# FMC Idaho LLC

## December 2004 RI Update Memorandum

**MARCH 2005 AMENDMENT PAGES  
TO BE INCORPORATED INTO THE  
DECEMBER 2004 RI UPDATE MEMORANDUM**

Figure 2-10: Conceptual Site Model for Potential Human Exposure to Contaminants at the FMC Operable Unit

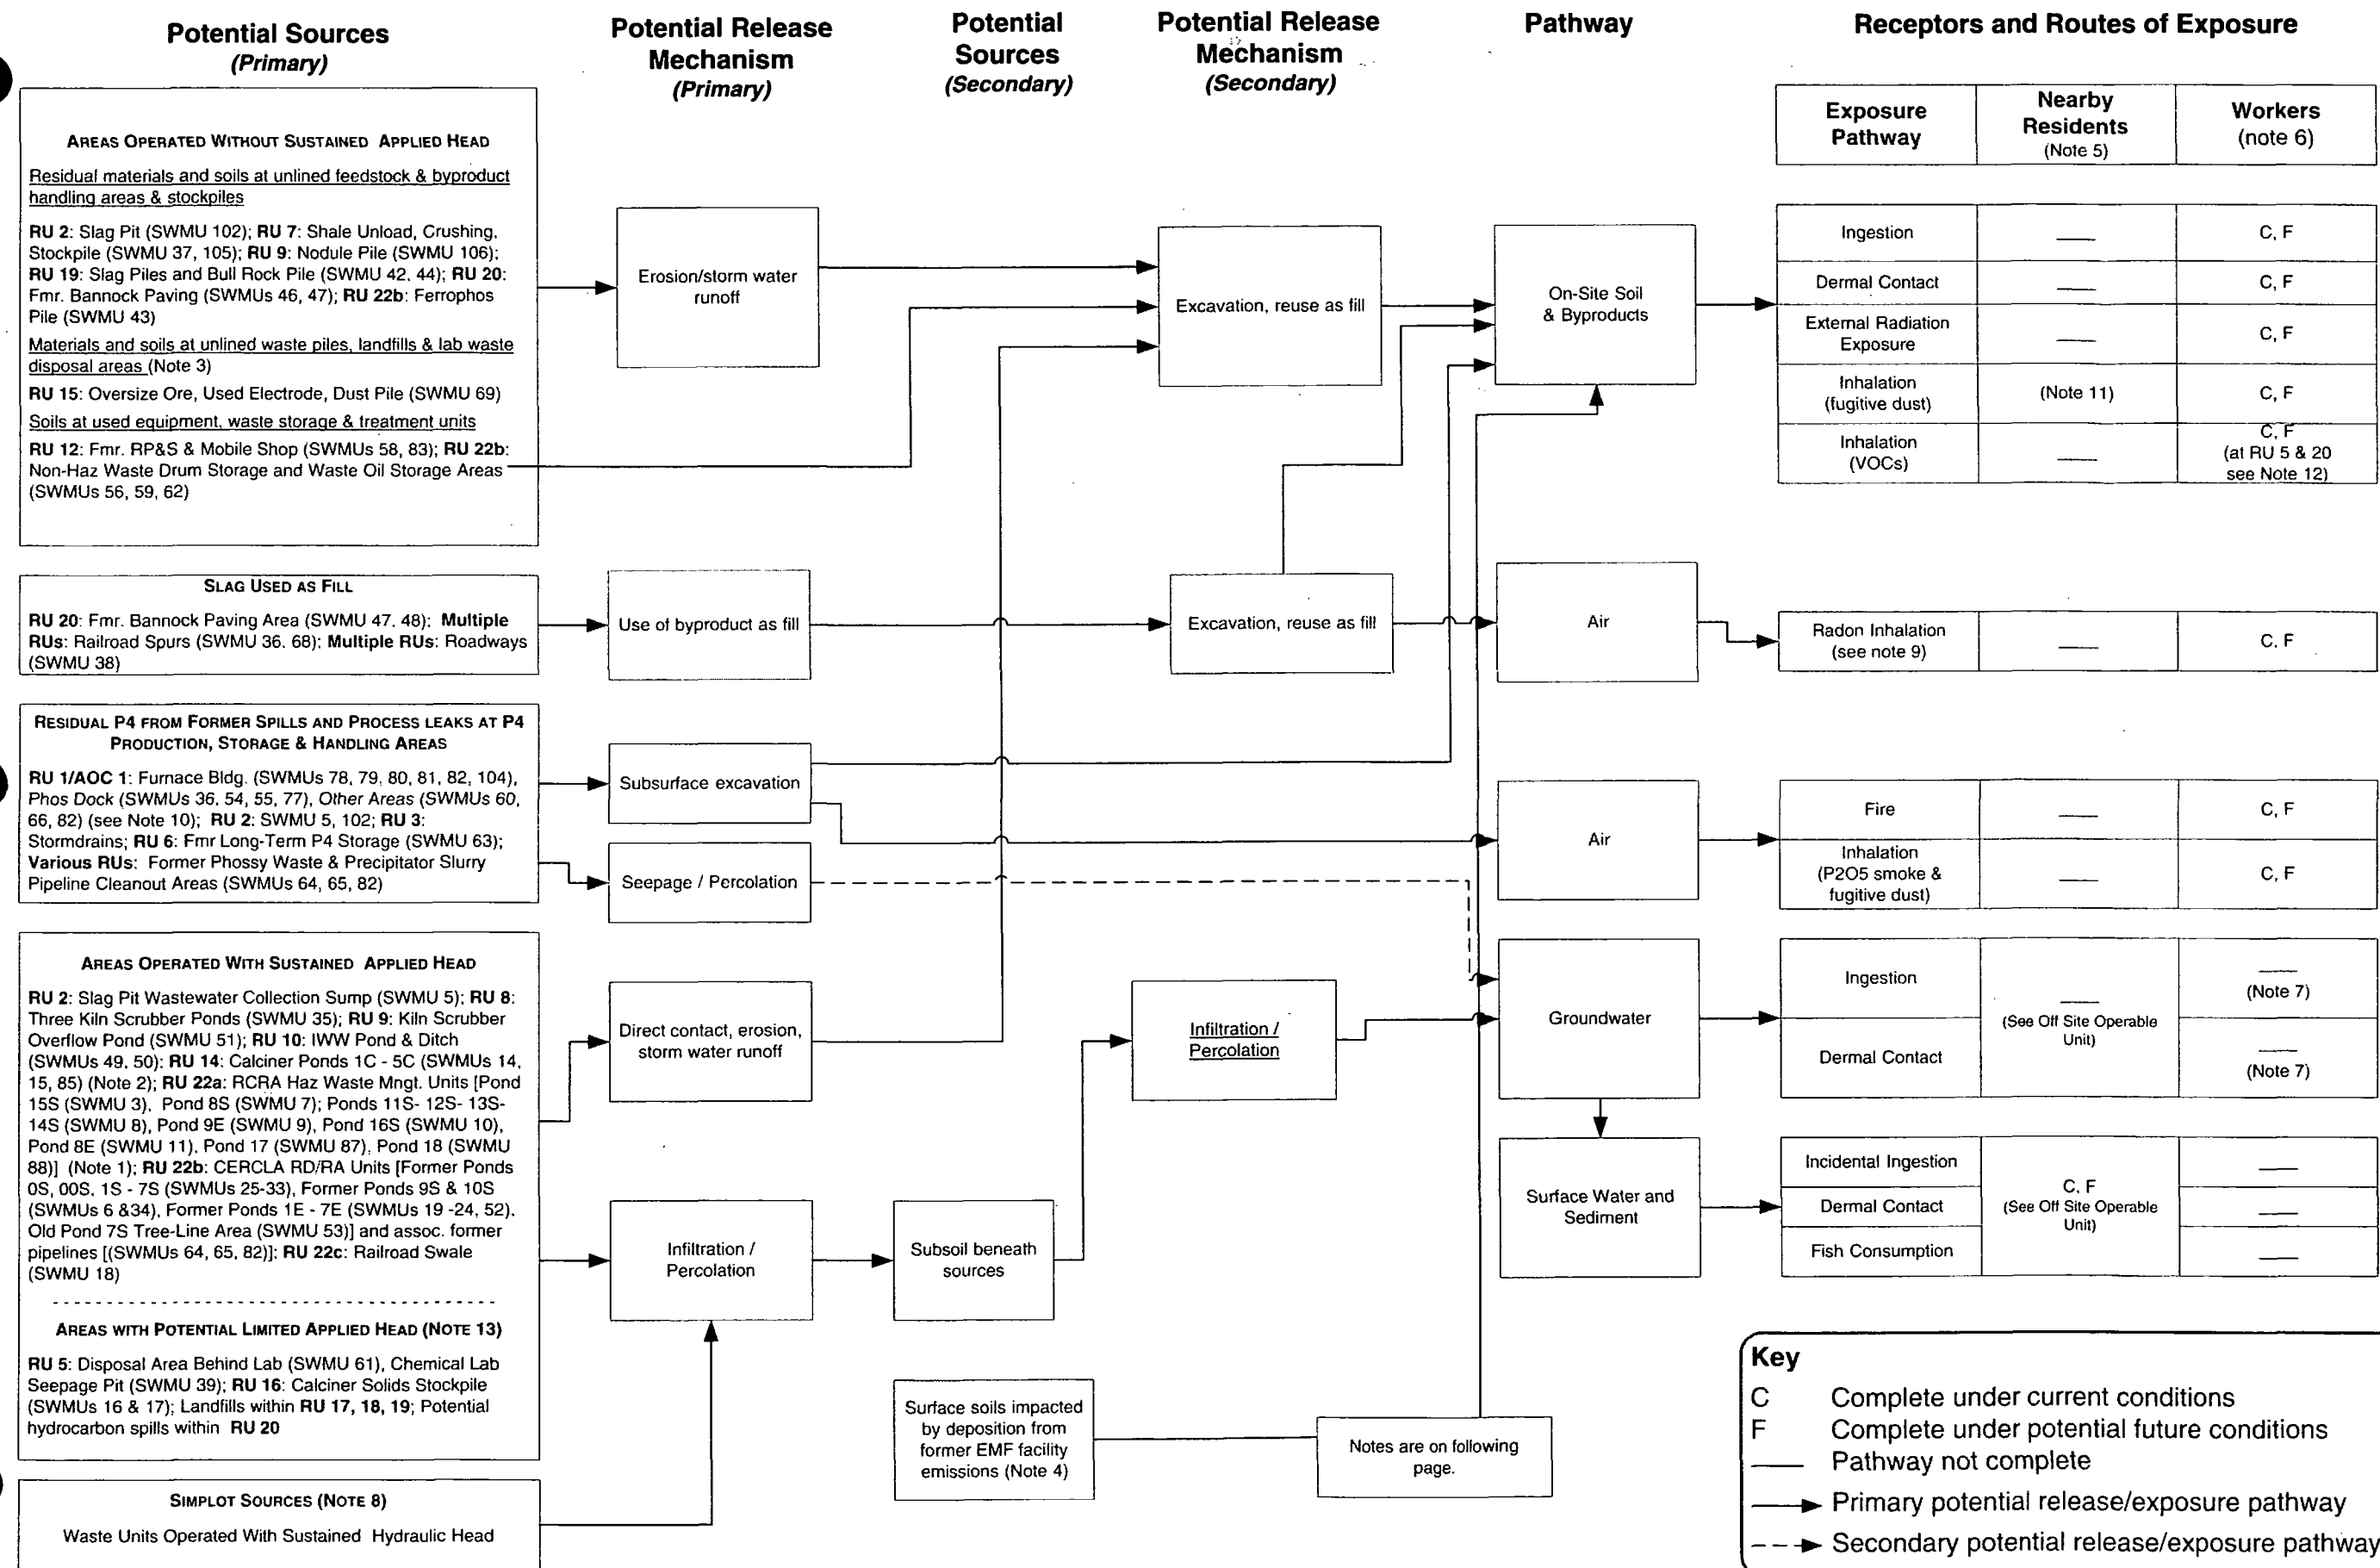
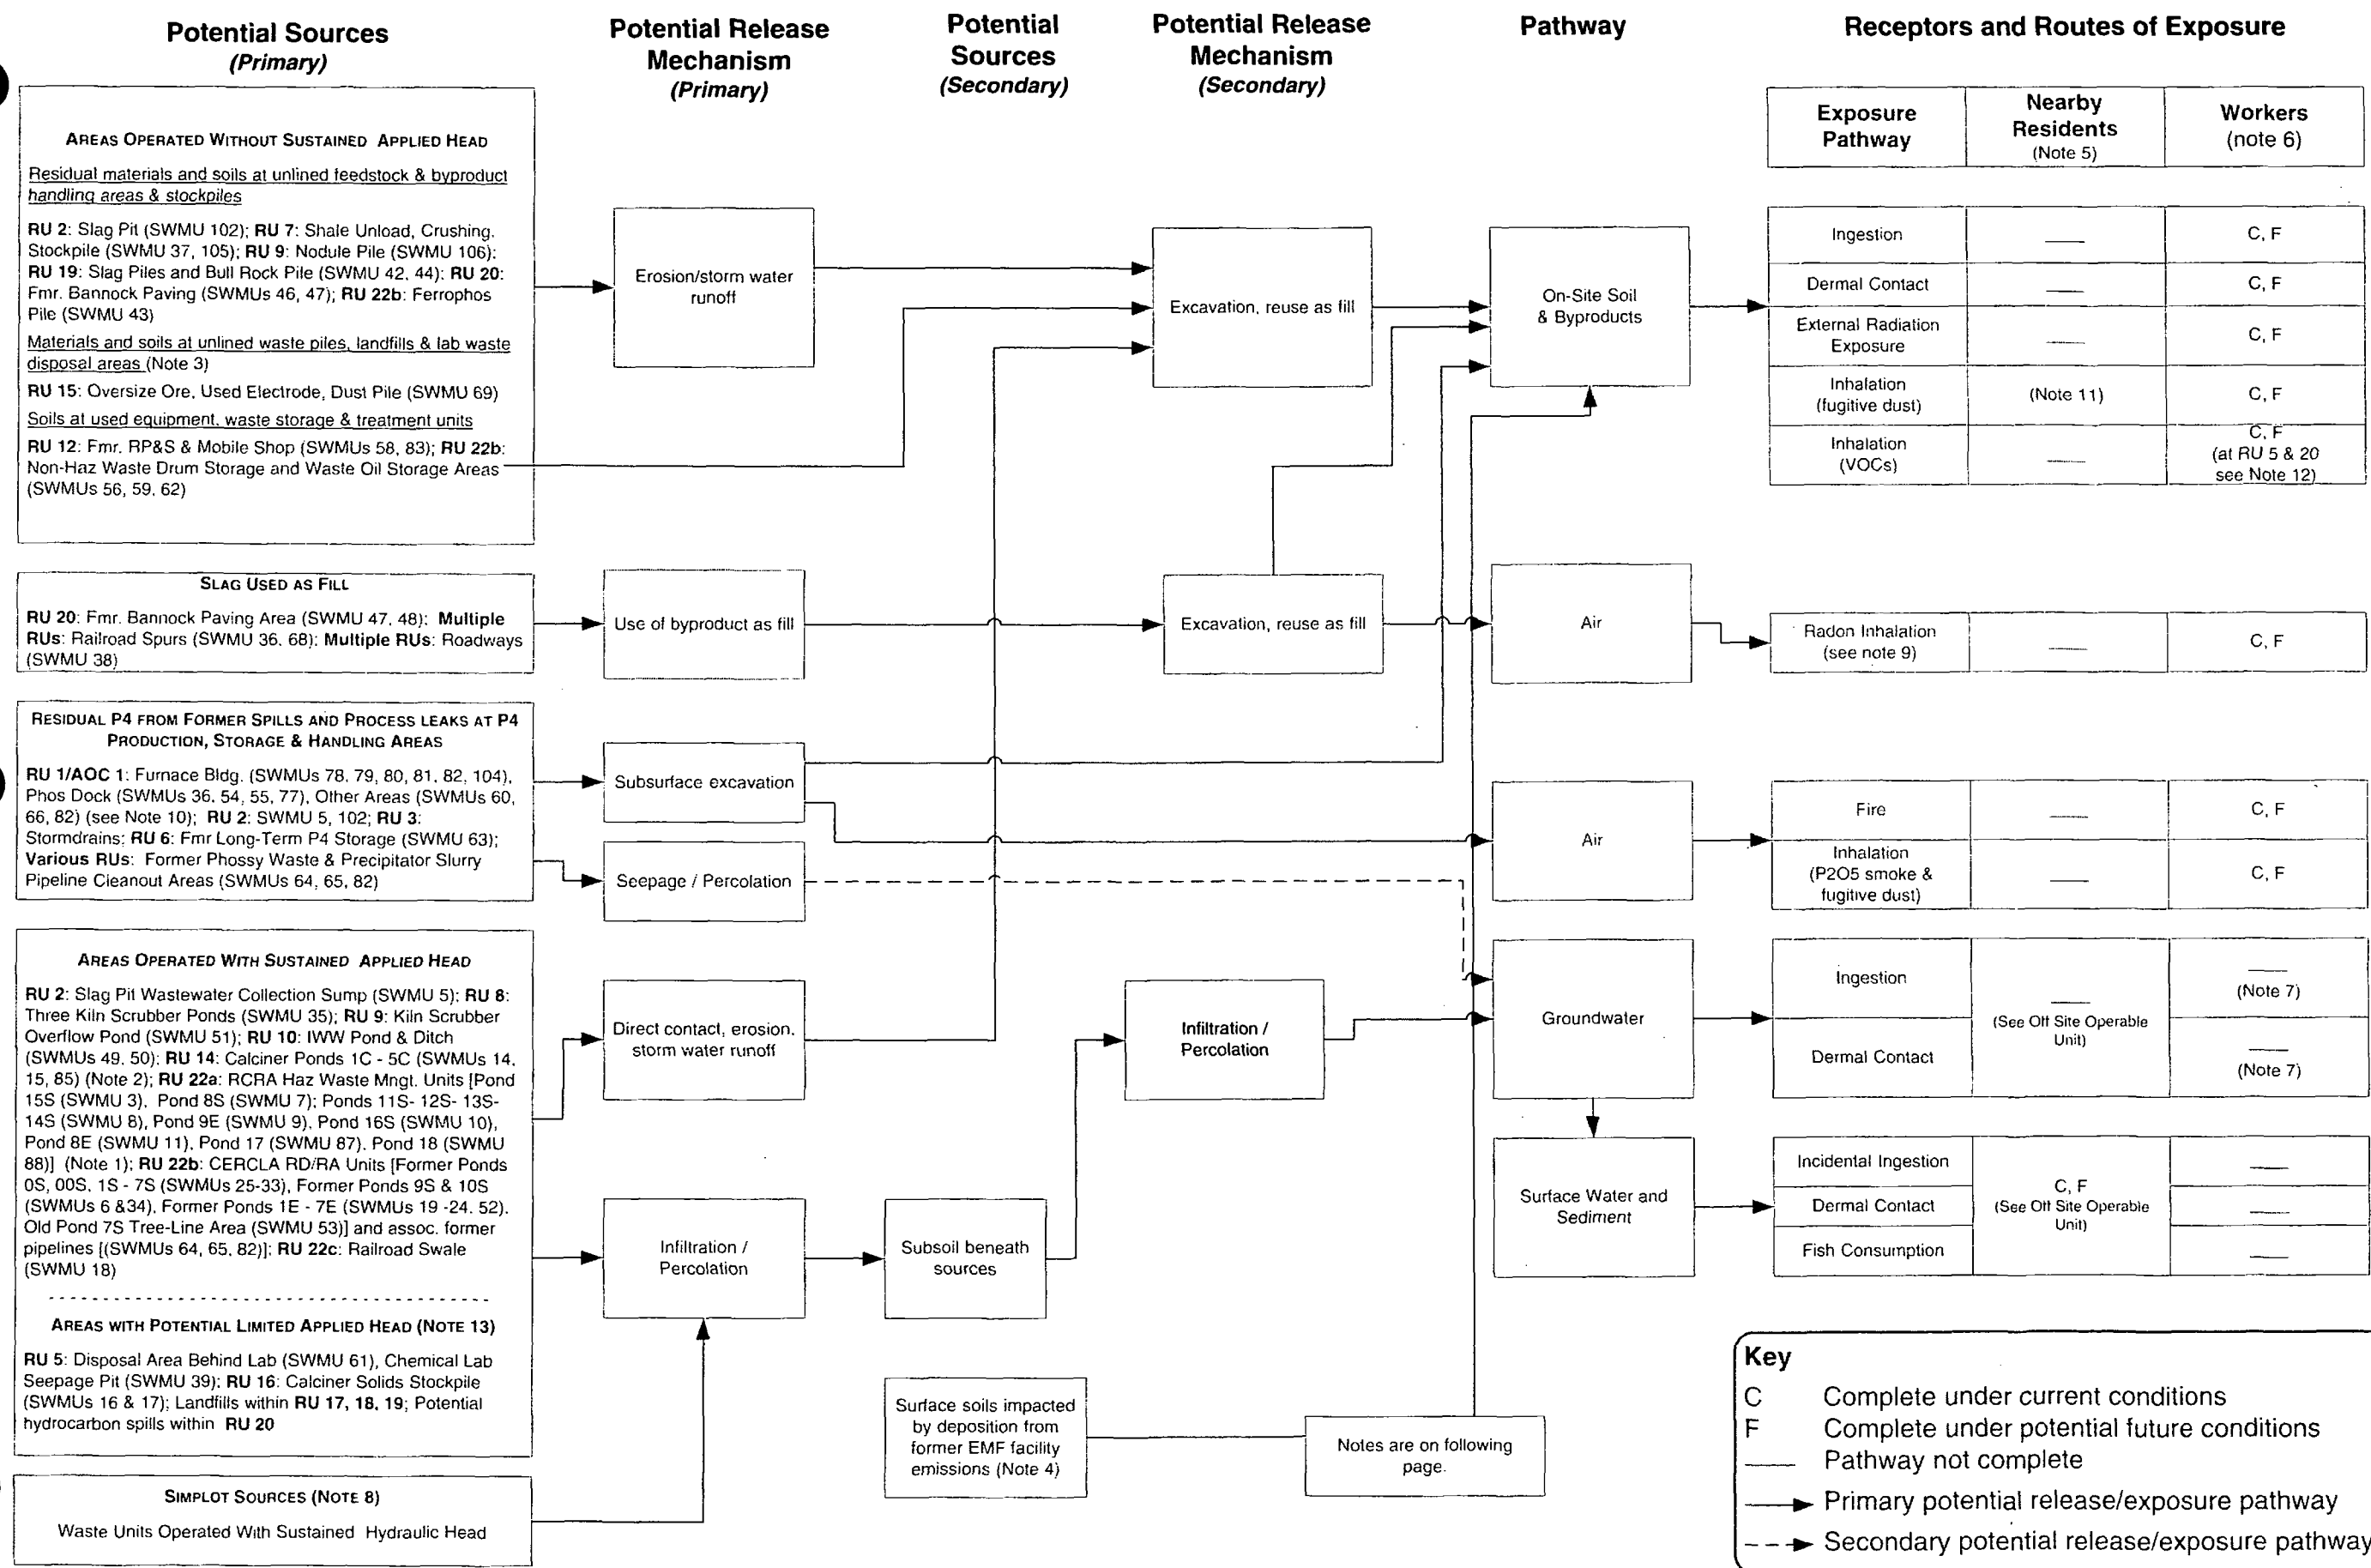
13. Comment 5. Figure 2-10 has not been revised. Although footnote 7 indicates that exposures are precluded through Institutional Controls, the CSM should identify secondary sources that could contribute to contaminant migration. The secondary source and release mechanism would be a concern if contaminants migrated from the pond waters to the pond sediments and then to the soil column beneath the pond. In this scenario, the source of continued contaminant migration need not be the pond sediments, but instead could be continued mobilization of contaminants currently present in the vadose zone. Thus the contaminated soil column is a secondary source through which we attempt to minimize infiltration. The original CSM identified the ponds as the primary source with infiltration/percolation as the primary release mechanism, and soil/sediment as a secondary source with infiltration/percolation as the secondary release mechanism.

As discussed in comment 3 and 10, it appears that infiltration/percolation is a viable release mechanism for sites operated without a sustained hydraulic head. Inorganic contaminants have also been shown to have migrated from waste sites under conditions without sustained hydraulic head (e.g., RU 16: Calciner Solids Stockpile; RU-5 Chemical Laboratory Seepage Pit). Figure 2-10 must be revised to include, in the list of units, the Slag Pit Wastewater Sump, and areas within the furnace building and phos dock as having been operated without sustained hydraulic head.

Please see the revision to Figure 2-10.

This comment was addressed in the proposed RI Update Memo revisions submitted to EPA on September 7, 2004. Figure 2-10 identifies "seepage/percolation" to groundwater from RU 1 and RU 2 SWMUs and P4 working areas, including the Phos Dock and Furnace Building. Note that the slag pit wastewater sump was operated with an applied head, and including it in the list of units as having been operated without a sustained hydraulic head would be incorrect.
